C-TEC R&D

New XFP Programming Tools (V7.0.8)

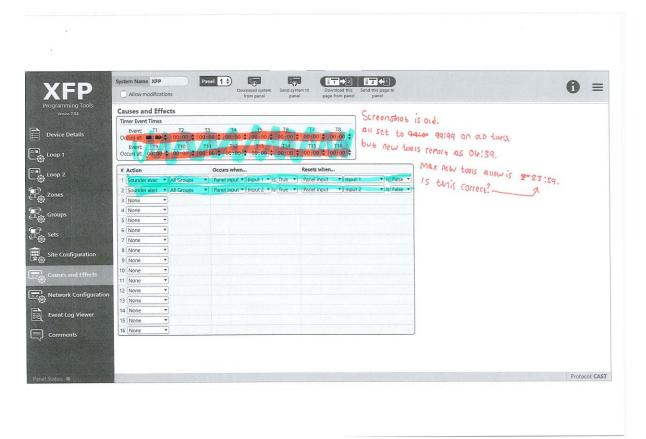
"Occurs at" strongly implies that a time of day is meant, not a length of time. I assumed that allowing 99:99 to be input was one of the old tool's quirks. When the new tool receives 99:99 from the panel it interprets it as 4 days, 4 hours & 39 minutes, giving a resultant time of day of 04:39.

The client and installer fields are not stored on the panel, only in config files.

Ant has confirmed that event times are times of day so I will leave the new tool as-is, apart from validating an incoming value and setting it to 0:00 if greater than 23:59.
